ADDENDUM NO. 02
LEGRANDE ELEMENTARY SCHOOL ADDITION AND RENOVATION
SCB PROJECT NO. 2210

DATE: August 23, 2023

The purpose of this Addendum is to clarify further the requirements of the plans and specifications. The bidders are governed by the information in this Addendum as if included in the plans and specifications. This Addendum does hereby become a part of the Contract Documents. Each bidder shall acknowledge receipt of this Addendum in the space provided in the Bid Form.

1 FIRST FLOOR PLAN - HYDRONICS DEMOLITION
SCALE: 1/8" = 1'-0"

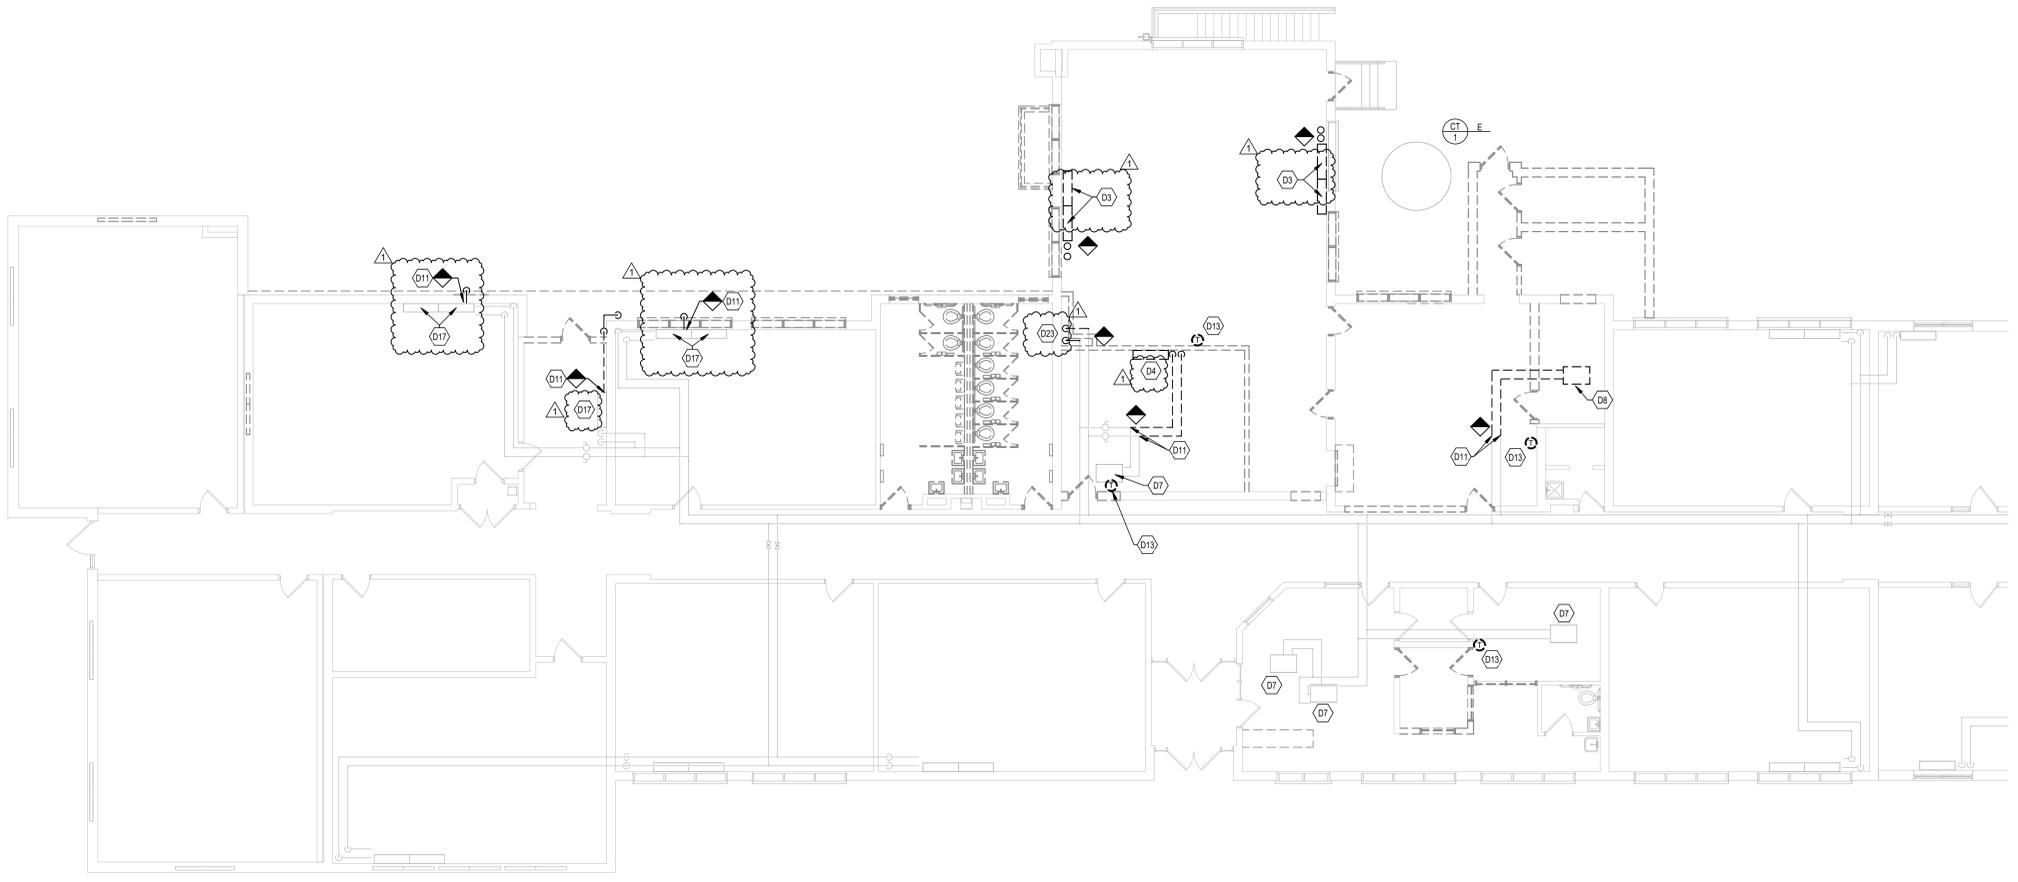
- b. Added Keynote D22.
3. Sheet M2.2 – First Floor Plan – Hydronics Demolition
 - a. Added demolition for existing console heat pumps condensate.
 - b. Added keynotes D3, D4, D17 and D23.

1 ROOF PLAN - MECHANICAL NEW WORK
SCALE: 1/8" = 1'-0"

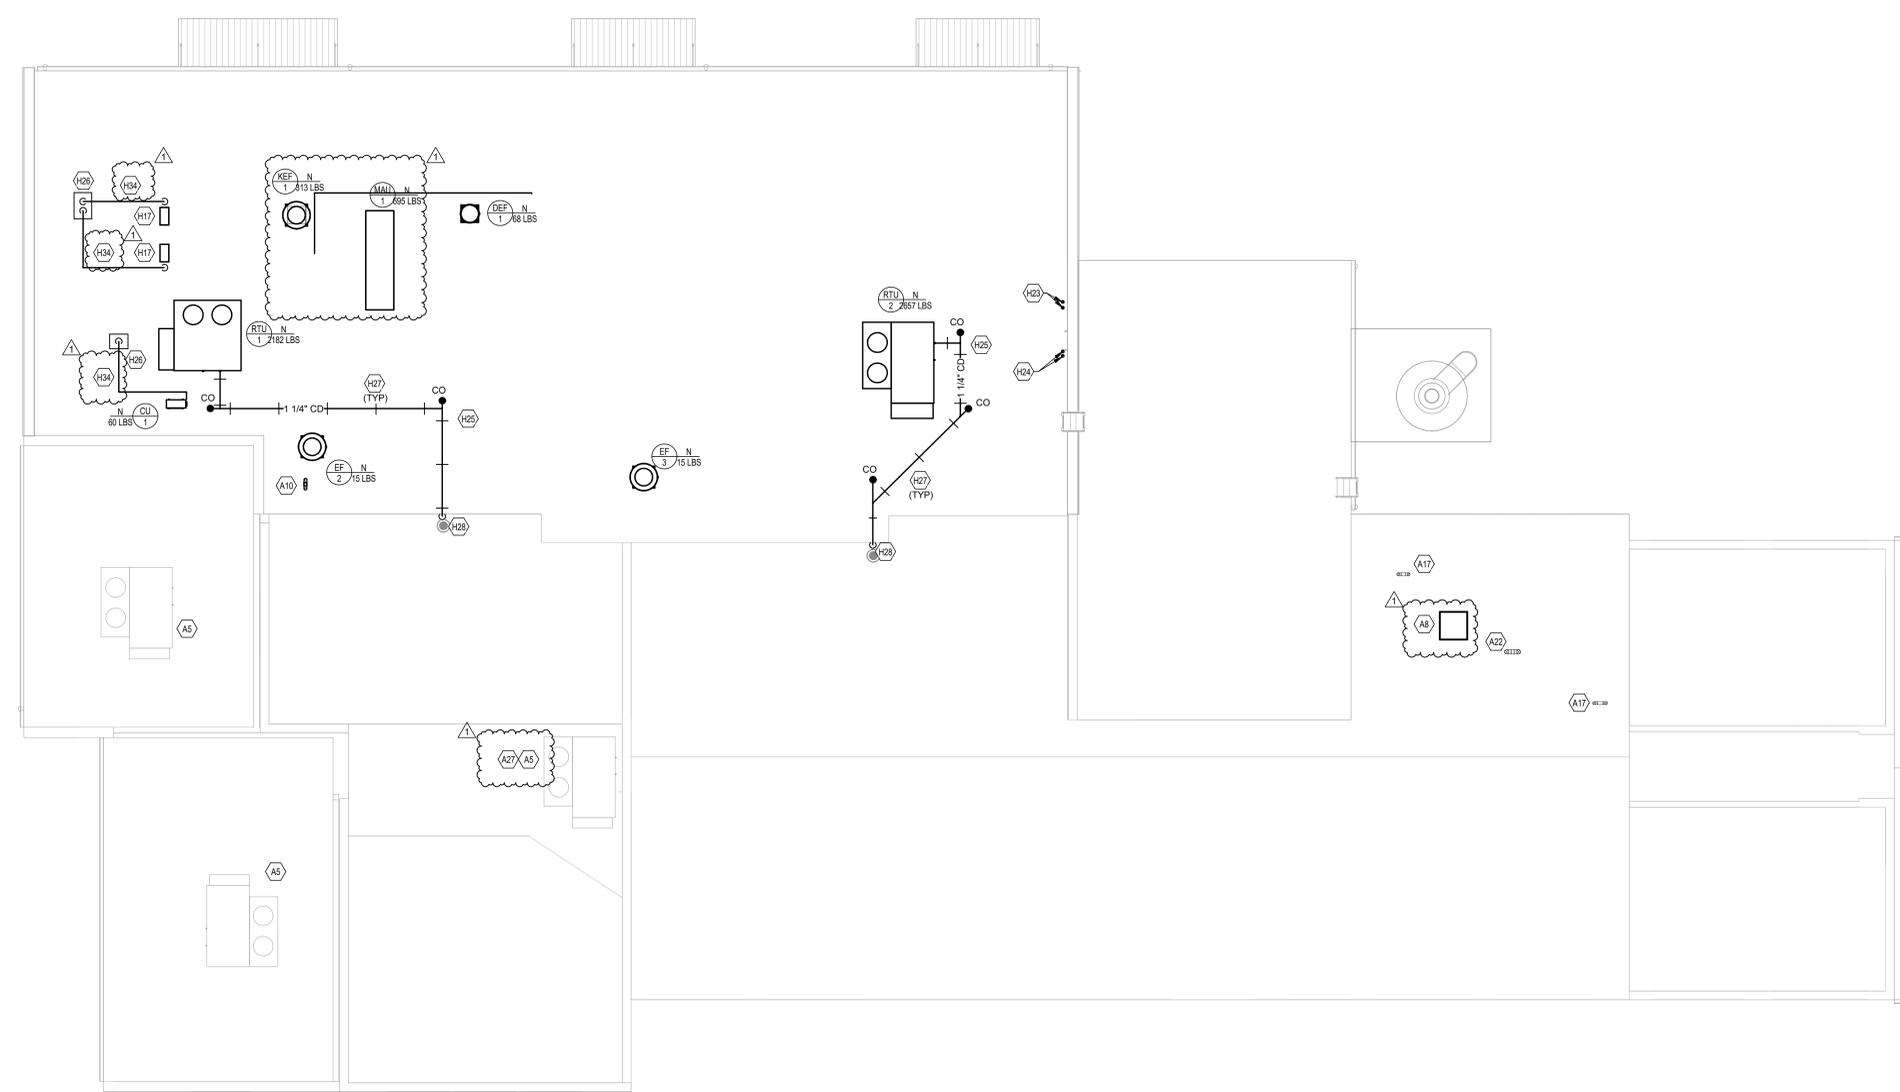
- f. Added Keynotes A24, A25 and A26.
5. Sheet M3.2 – Roof Plan – Mechanical New Work
 - a. Revised MAU-1 & KEF-1.
 - b. Added Roof Curb Cap for removed kitchen exhaust fan.

- c. Added Keynotes A27 and H34.
6. Sheet M4.1 – First Floor Plan – Hydronics New Work
 - a. Revised condensate piping for existing console heat pumps in Computer 112, Classroom 114 and corridor.

1 FIRST FLOOR PLAN - HYDRONICS NEW WORK
SCALE: 1/8" = 1'-0"

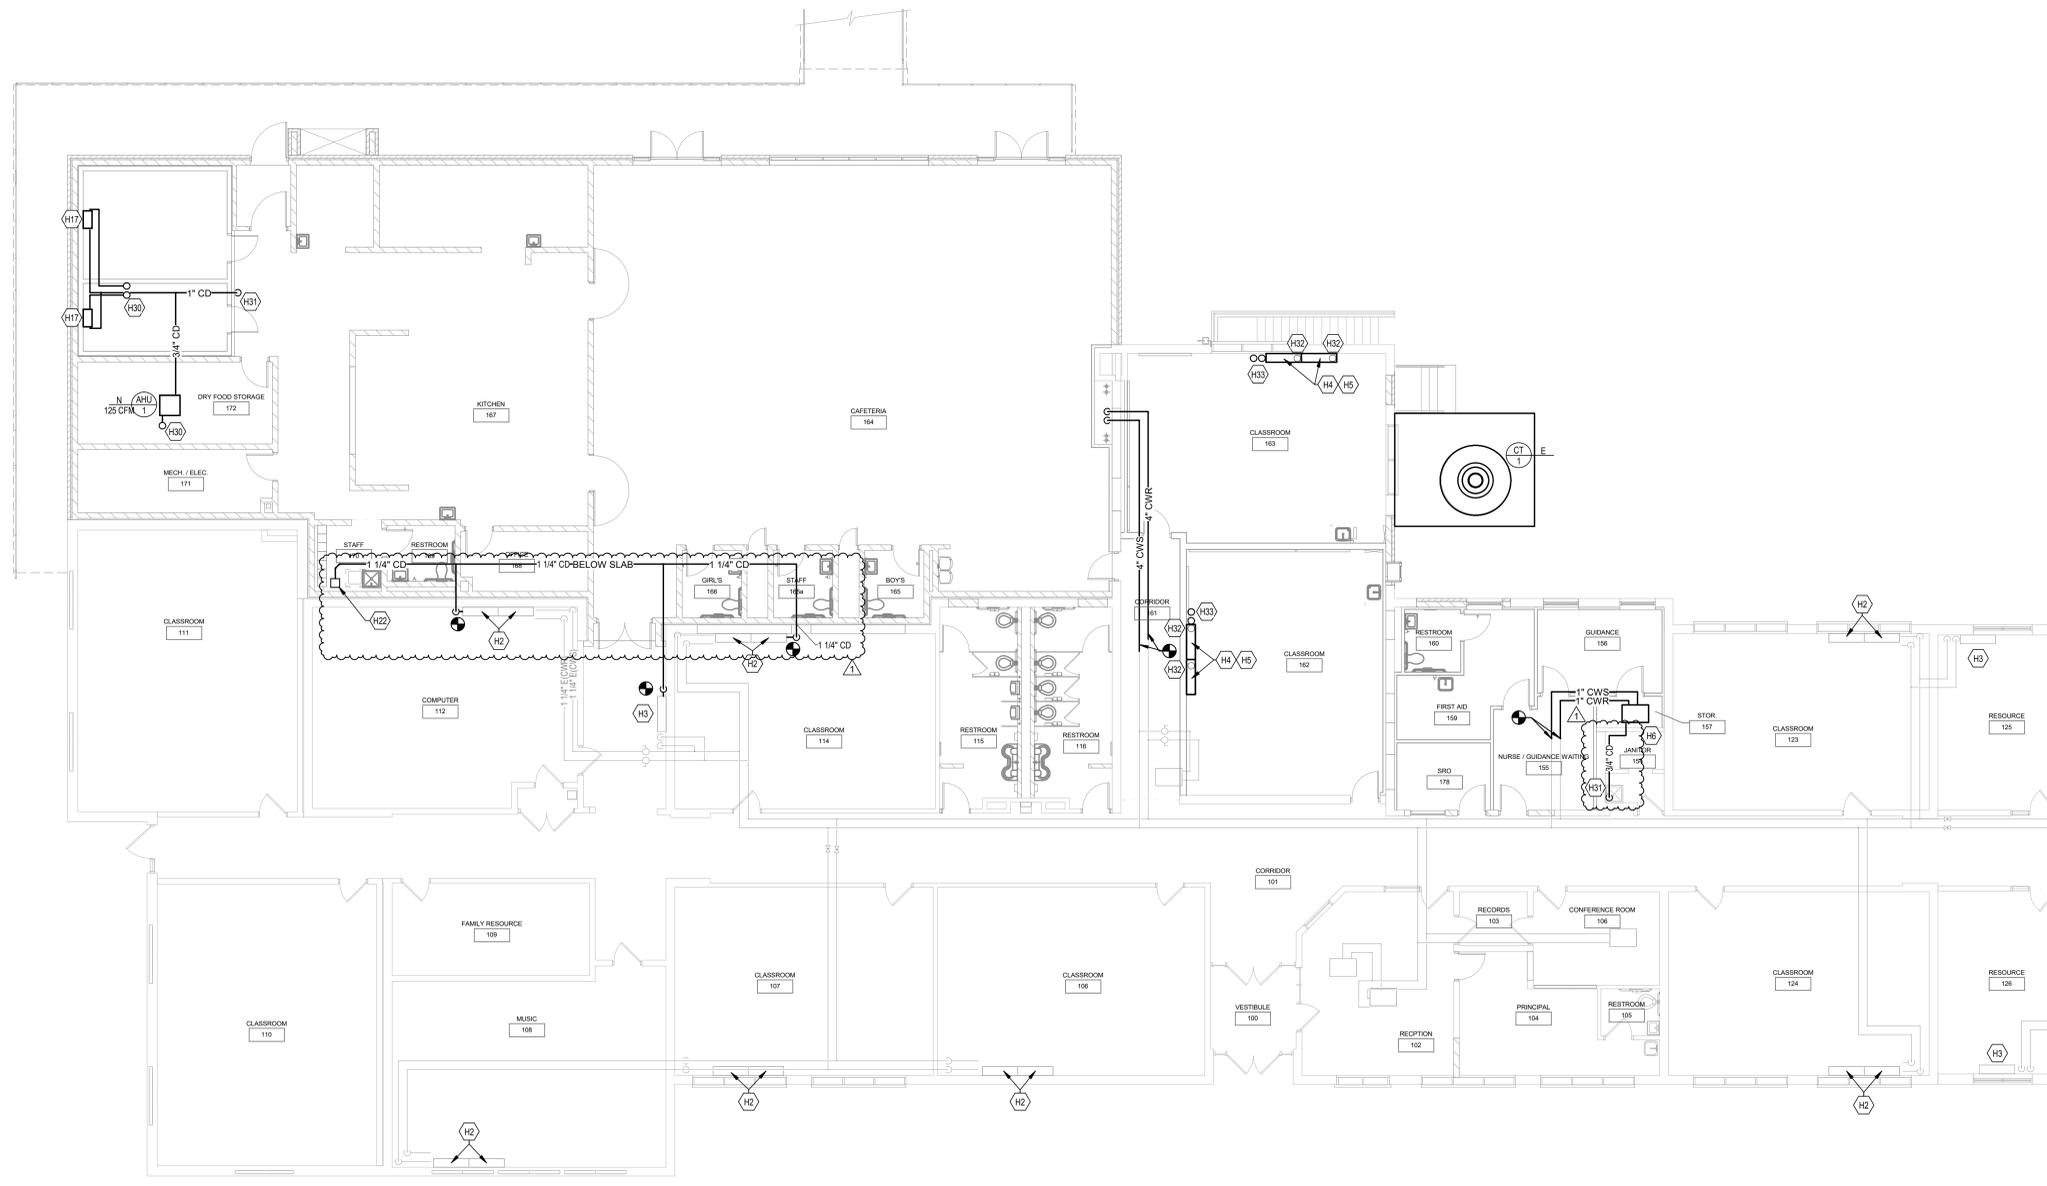
- b. Added size for existing heat pump condensate in Guidance 156.
7. Sheet M5.1 – Mechanical Details
 - a. Revised Detail 4 – Typical Air Handler Condensate Drain Trap Detail.

FP1.0

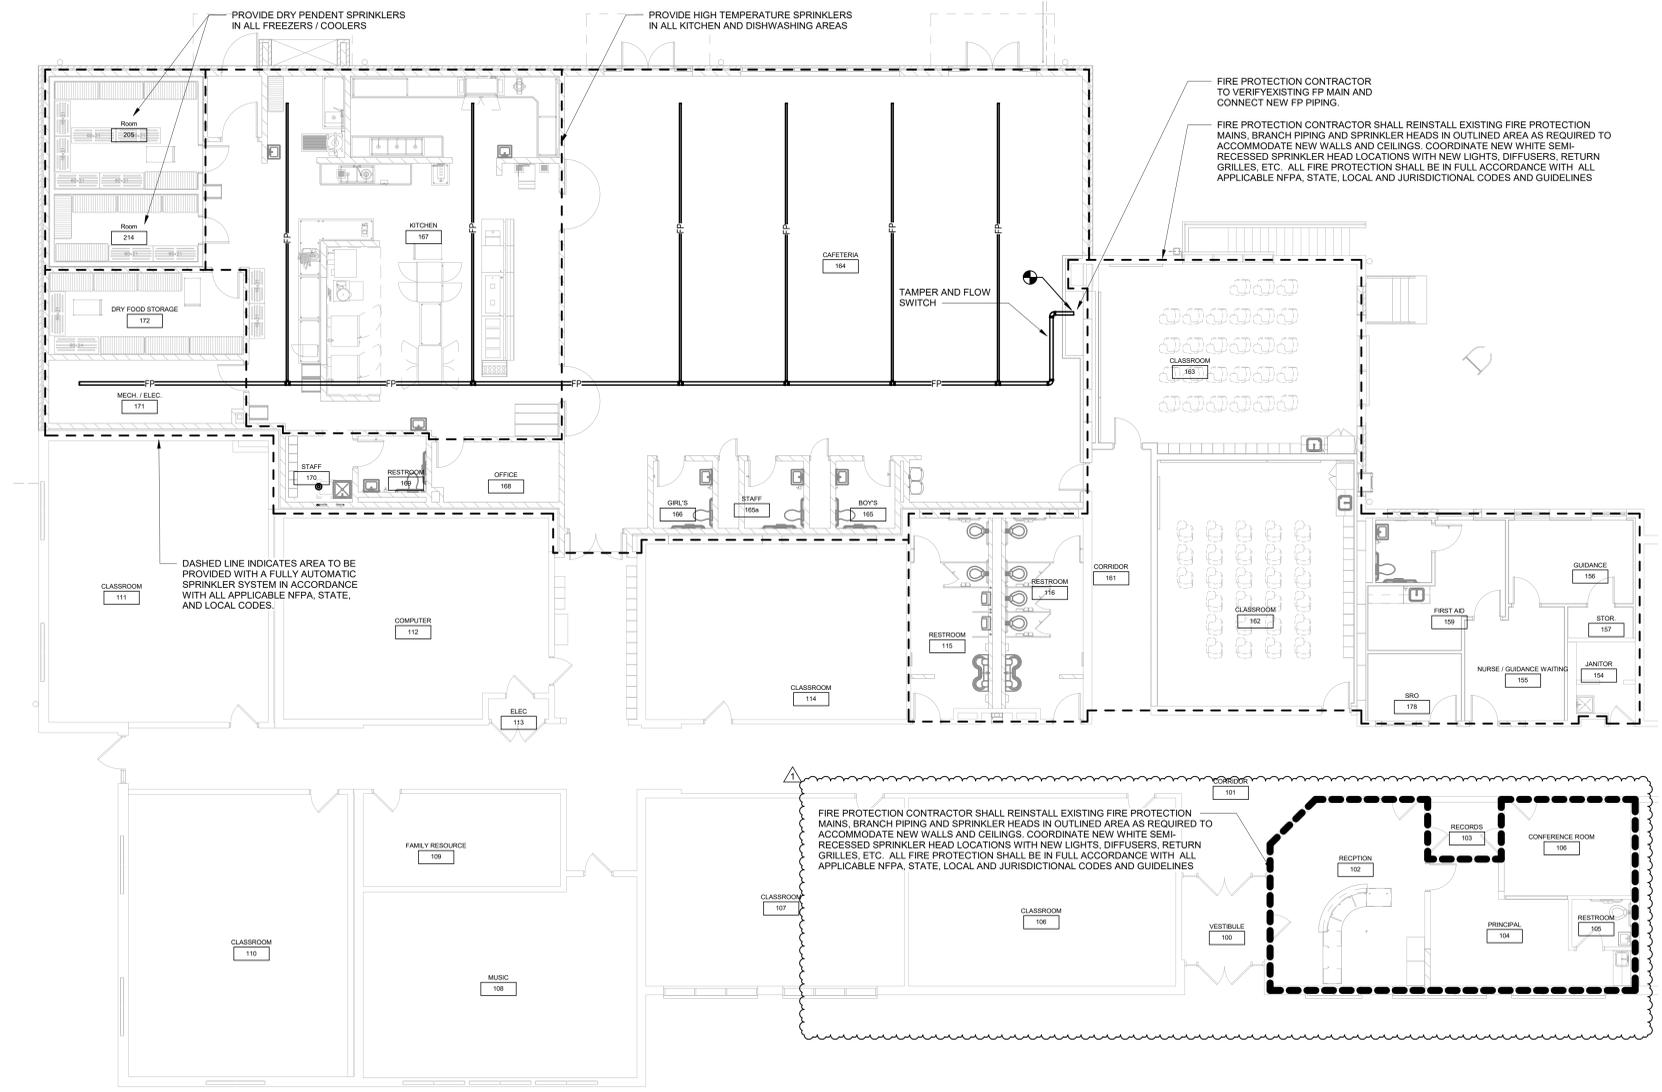
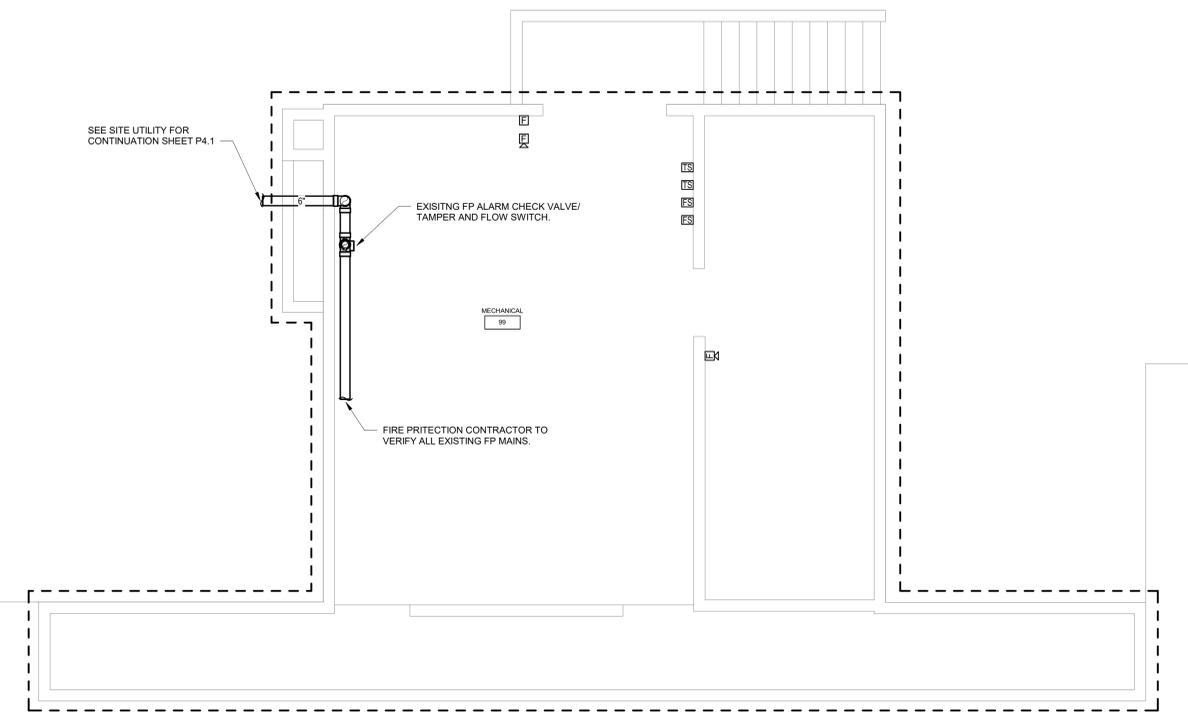
1. Sheet FP-1.0
 - a. Added Fire protection scope to drawing.
2. Sheet FP-1.1
 - a. Added Fire protection scope to drawing.

1 FIRST FLOOR PLAN - PLUMBING
SCALE: 1/8" = 1'-0"

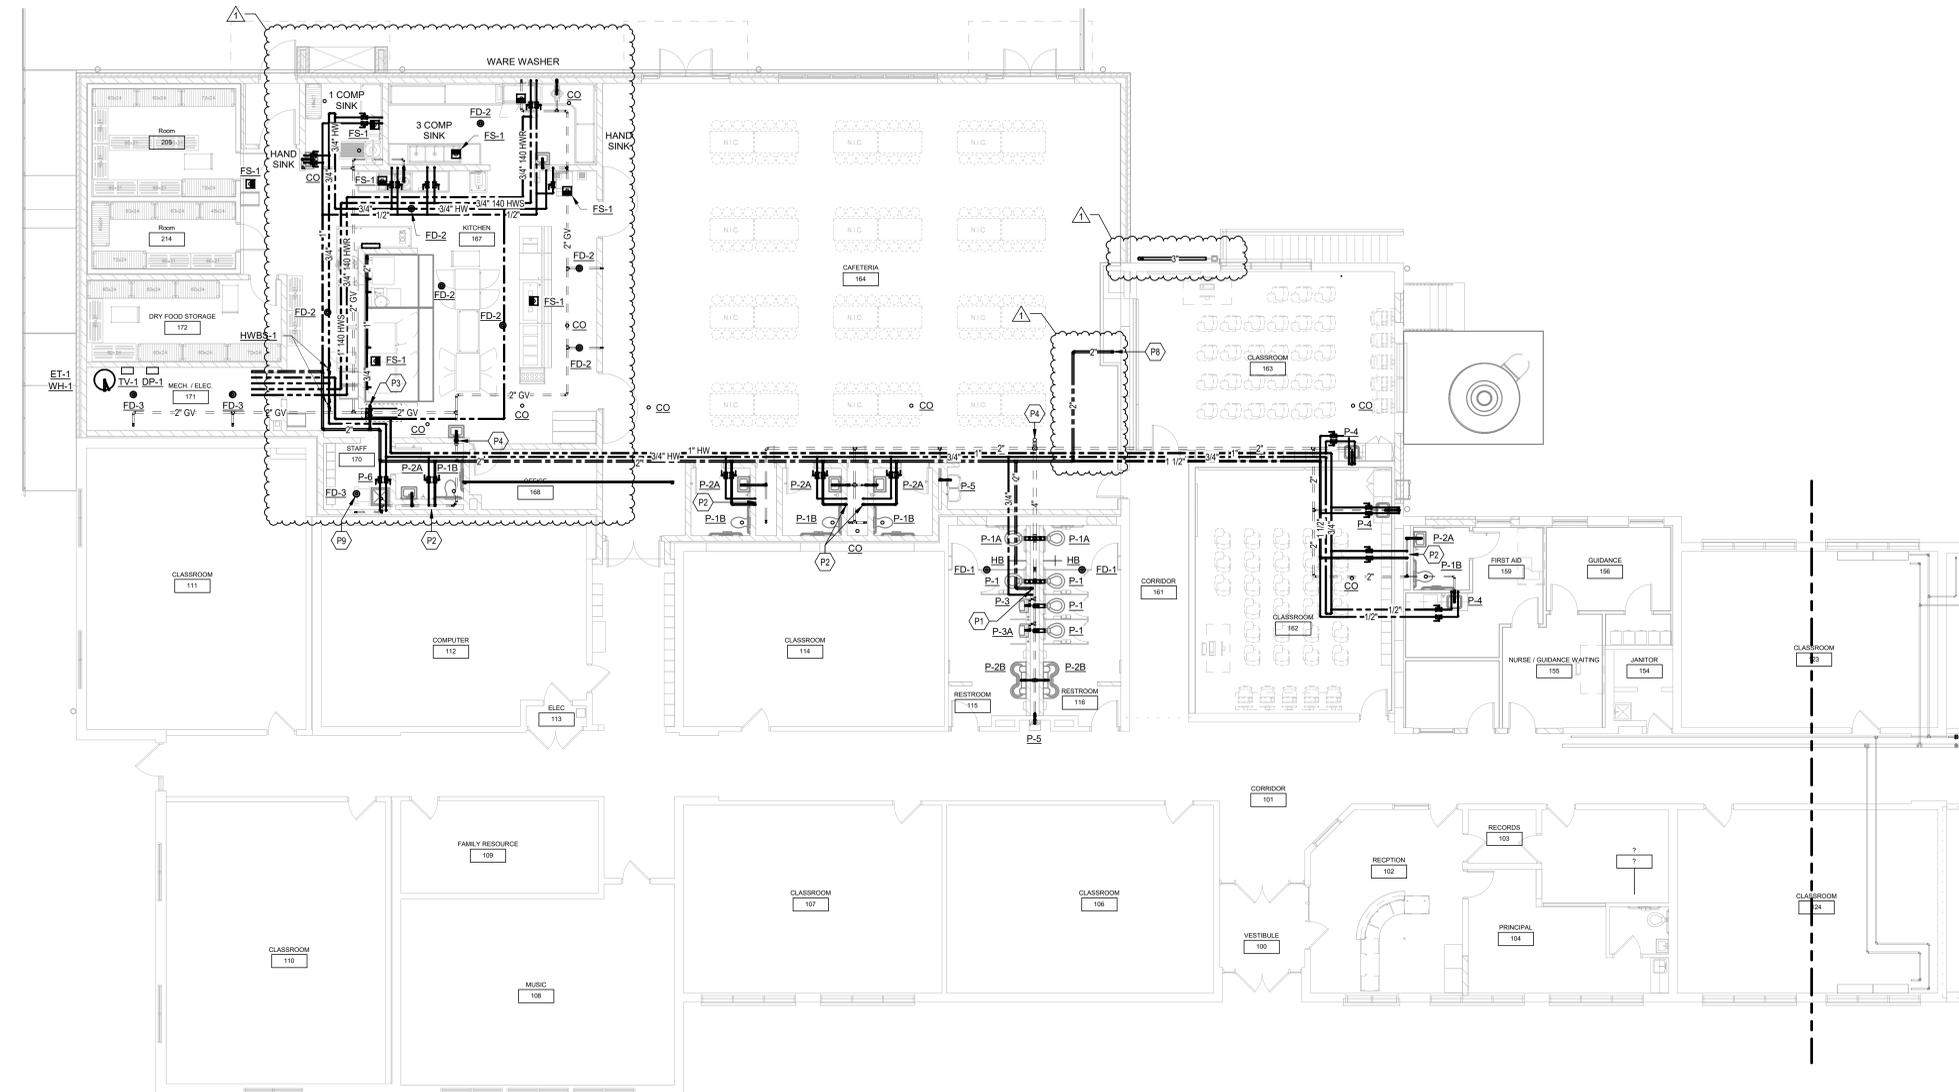
2. Sheet P2.2– First Floor Plan – Plumbing
 - a. Added 3” natural gas piping gas meter to be re-worked by local utility
 - b. Added 2” domestic water down in basement mech room and connected to main
 - c. Added gas to reworked gas fires kitchen equipment
 - d. Added floor drain for mech condensate pit
 - e. Re-worked kitchen waterlines and sanitary
